Memorandum

Date: June 29, 2018

Re: Expert Panel Review of Version 1.0 of the
Ventura Regional Groundwater Flow Model (VRGWFM)
(Ventura County, California)

Figure 3. Example Calibration Hydrograph for a Well with a Good Match

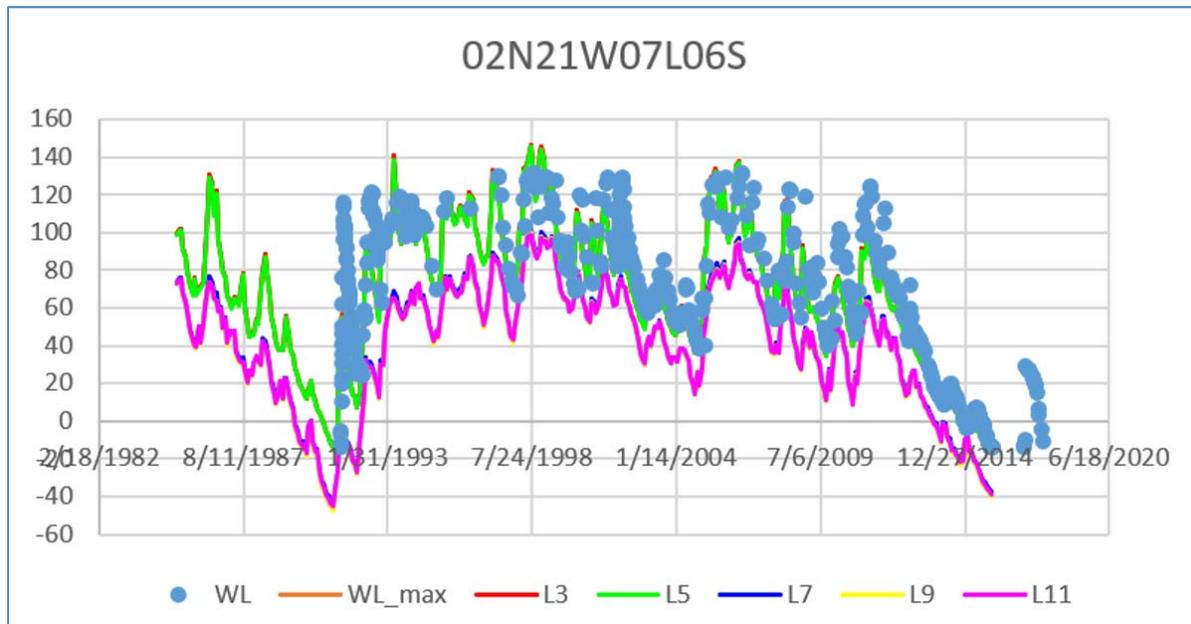
Hydrographs provided by UWCD show field measurements and model-simulated water levels in each layer penetrated by the well. The panel reviewed 270 hydrographs to determine the number of good matches and poor matches. As an example of the visual inspections of each hydrographs, Figure 3 shows a good match while Figure 4 shows a poor match.

Figure 5. Scatter Plot for Groundwater Elevations

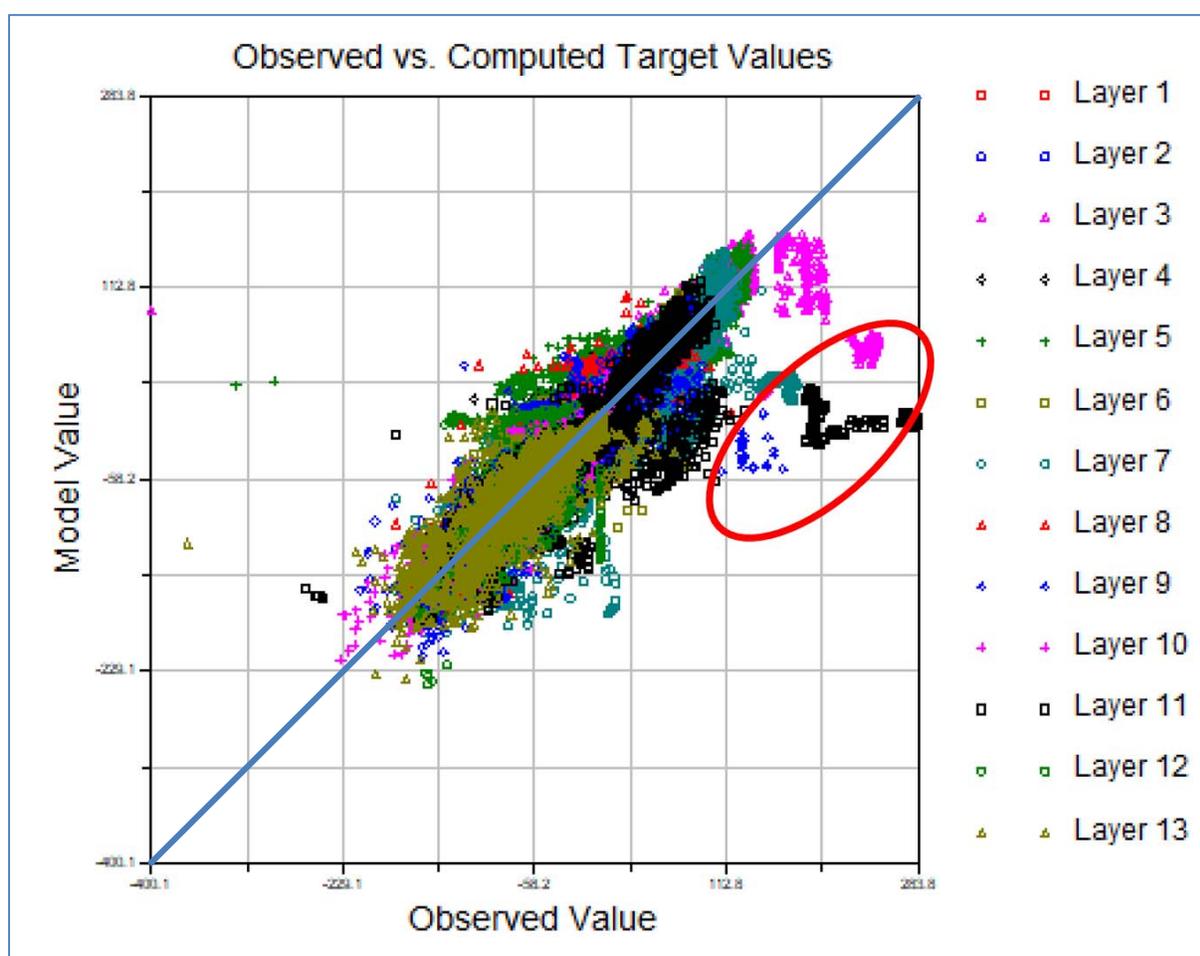
Another visual representation of calibration quality is a scatter plot of observed versus simulated water levels. In an ideal calibration, the values fall on a straight line at a 45 degree angle. The degree of scatter and any bias in the line of best fit provide information on the degree of regional spatial bias. The scatter plot generated by the panel for the water level elevation calibration is shown in Figure 5. Except for some outliers (shown in red ellipse) the degree of scatter about the 45 degree line is good and does not indicate the existence of any significant spatial or temporal bias.

Figure 6. Scatter Plot for Changes in Groundwater Elevations

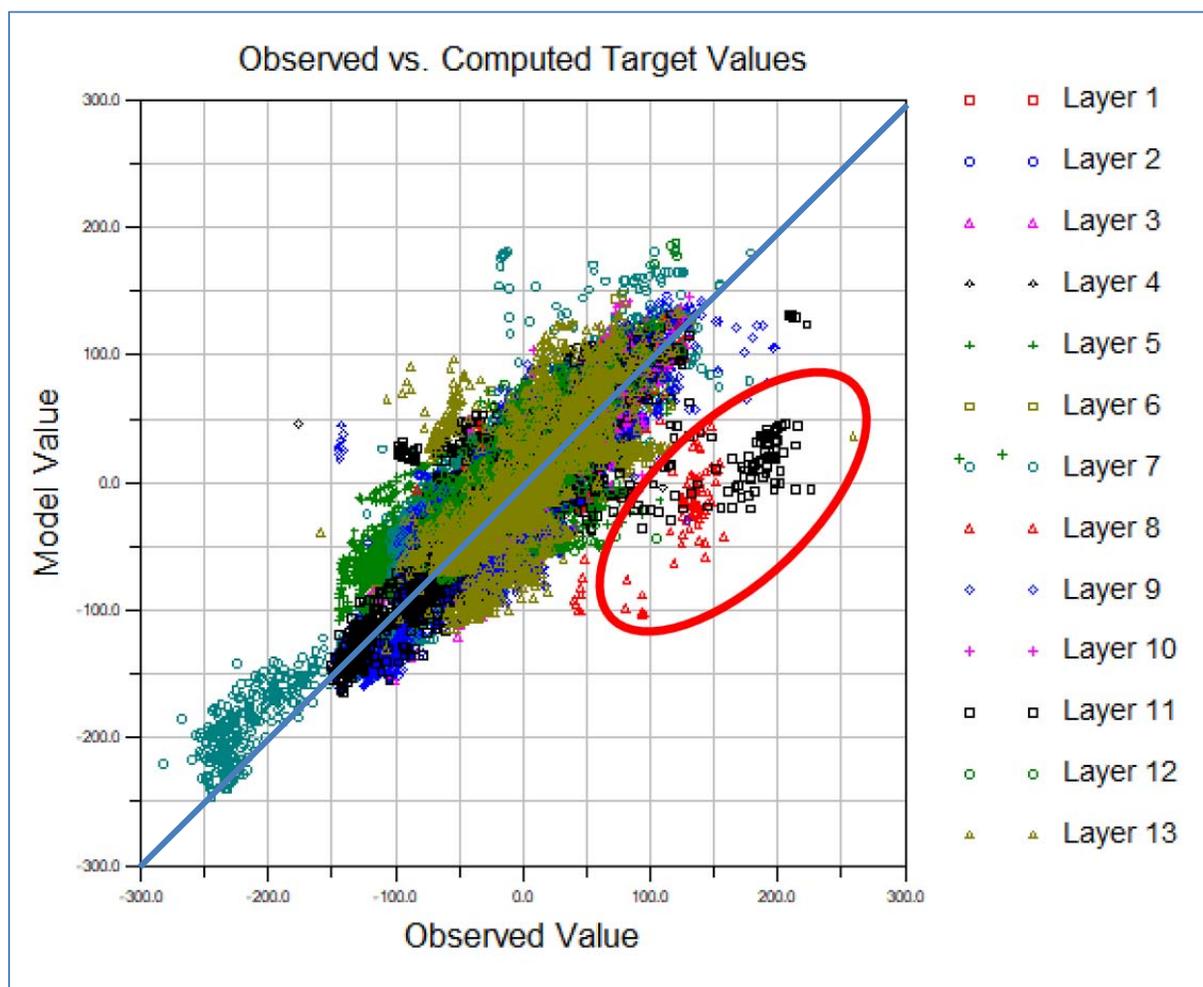
The same sort of scatter plot for change in head is shown in Figure 6. The degree of scatter is similar to that for the elevation match, and again no significant bias is shown.

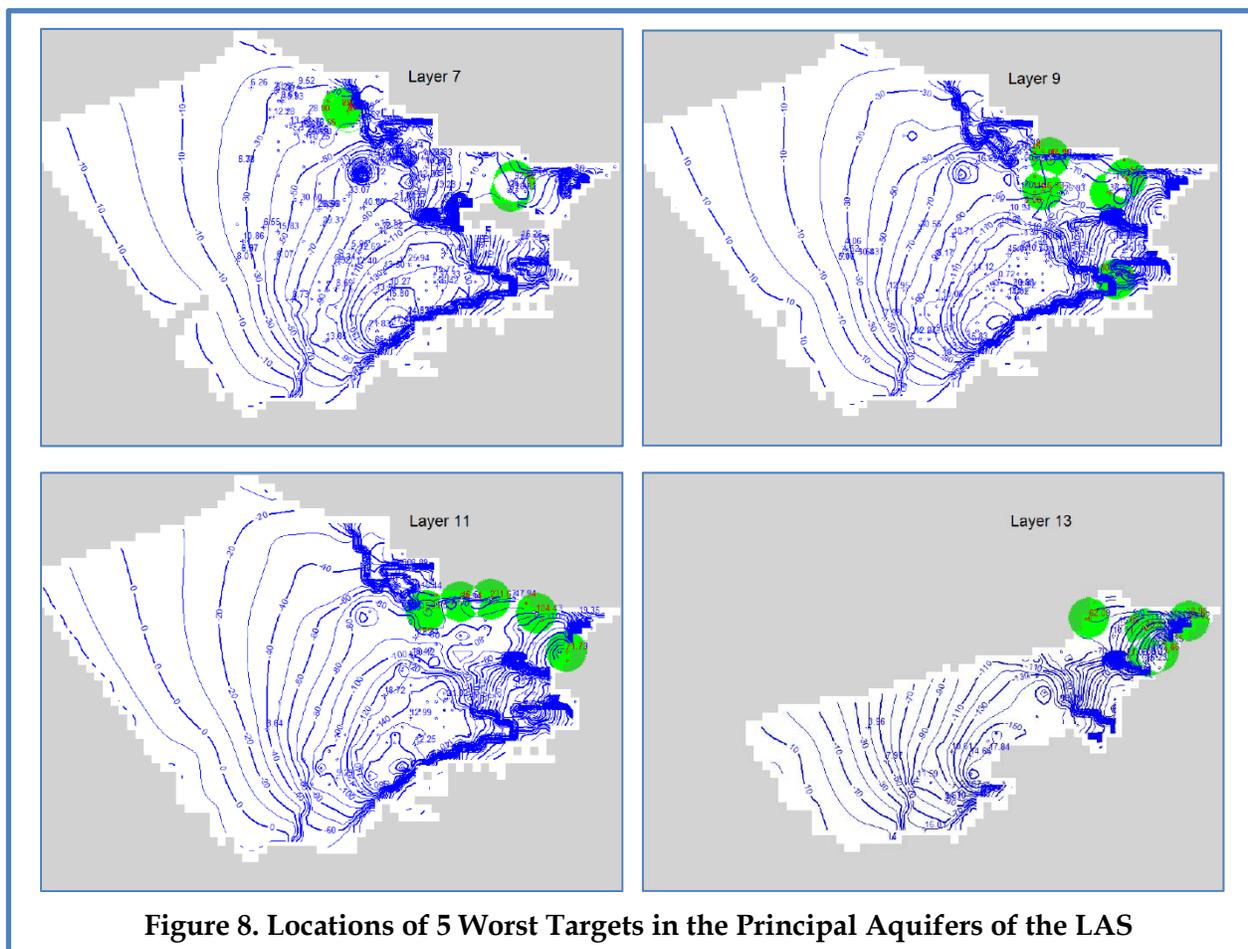
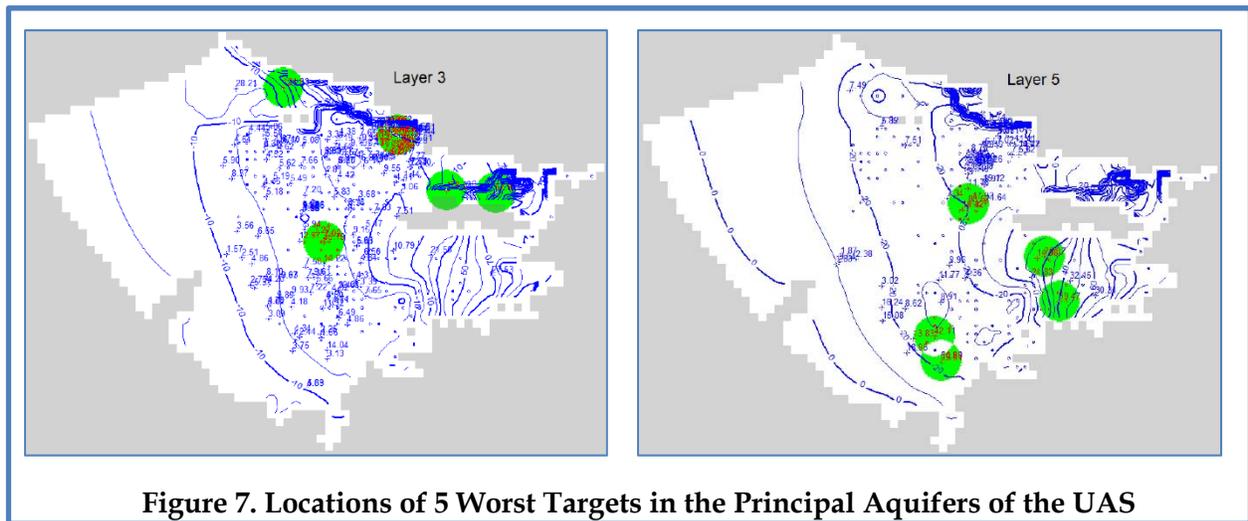
Figure 7 shows maps of the location of the worst matches in two model layers in the UAS (the Oxnard Aquifer in layer 3, and the Mugu Aquifer in layer 5). Each map uses green dots to show the locations of the five worst hydrographs in a given model layer. Figure 8 shows similar maps for the four principal aquifers in the LAS (the Hueneme Aquifer in layer 7, the Fox Canyon Aquifer’s upper and basal units in layers 9 and 11, and the Grimes Canyon Aquifer in layer 13). Together, these maps provide an understanding of the spatial distribution of error by allowing for identification of the existence (or lack thereof) of spatial bias in the locations of poorly matched wells. As shown by these figures, the worst hydrographs tend to lie (1) on or near the outer boundaries of the model, where groundwater gradients are steep due to topography, faulting, and/or significant rates of recharge, and (2) at locations inside the model domain where hydraulic gradients are steep because of groundwater pumping. The occurrence of the largest errors in places with steep gradients is not surprising, given that groundwater elevations may differ by tens to hundreds of feet between the 2,000-foot wide model grid cell containing the green dot and one or more of its neighboring grid cells of equal size. The use of refined grid spacing in future applications of the model likely would cause simulated groundwater elevations (and changes in elevations) to more closely match observed conditions; accordingly,

adjustments to hydraulic parameters in the model are not warranted in these areas without first conducting further testing and evaluation using refined grids.
